TO: Mercedes-Benz Dealer Principals, General Managers, Sales Managers, Service Managers, Parts Managers	FROM: Gregory Gunther, Department Manager, Vehicle Compliance and Analysis, Engineering Services
RE: Recall Campaign Update Notification Rework Air Conditioning (AC) Drain Hose MY20 GLE-Class, GLS-Class (167/X167 Platform)	DATE: September 18, 2019

Campaign No. 2019080005, August 2019

SUBJECT: **Model GLE-Class, GLS-Class vehicles, (167/X167 platform)
Model Year 2020
Check condensation drain hose at right and left of air conditioning system,
rework if necessary**

Figure 1

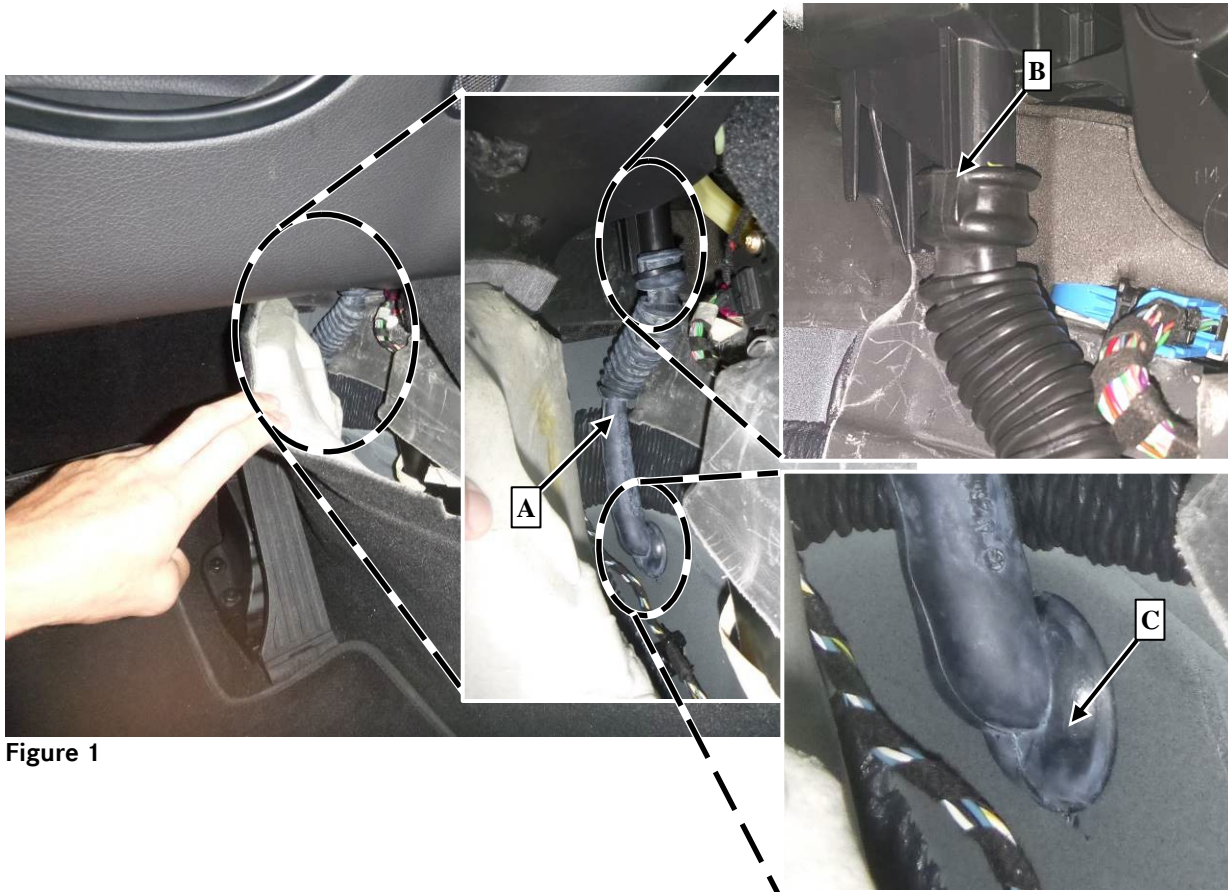
1. Release floor covering in footwell on driver's and front passenger side and check condensation drain hose at right and left of air conditioning system (**Figure 1**).

- i** The condensation drain hose must be installed without creases in proper-seated position and inserted correctly on the heater box or tunnel (**C, Figure 1**).
- i** The cutout (**B, Figure 1**) must be positioned correctly on the fitting of the heater box.
- i** There must **not be any visible or noticeable traces of water**.

- a. Condensation drain hose **not** fastened correctly: Carry out **check/test procedure B**.
- b. Condensation drain hose fastened correctly: **End measure**.
